SERVICE BULLETIN – 01/MARCH 2004

SPR 80

NEW LOCATION OF THE ICE LEVEL CONTROL

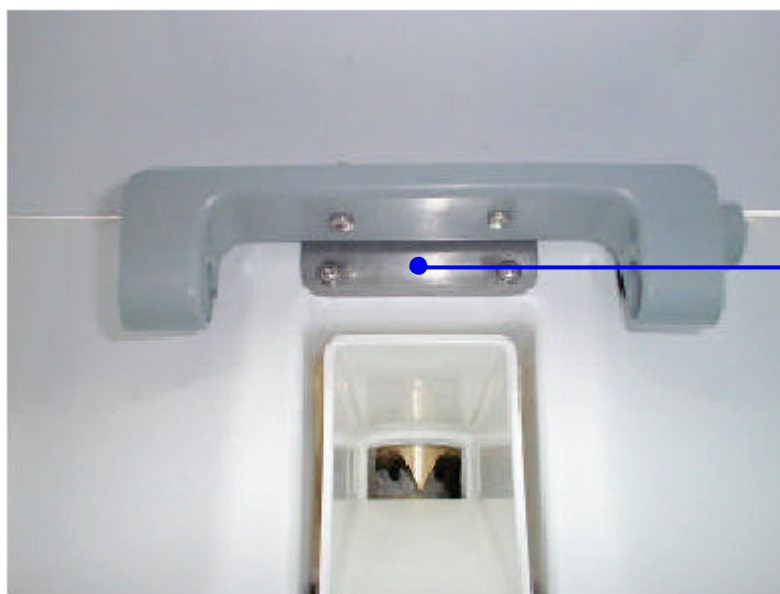
The Optical Ice Level Control has been moved from the upper side of the plastic ice spout into the storage bin, just above the outlet of the plastic ice spout (see photo below).

This modification increased the capacity of the storage bin by 5-6 kgs.

The installation of the Optical Ice Level Control on the new location has required a small modification on the upper side of the storage bin mold as well as the use on a new S.S. bracket Part Number **724373 00**.
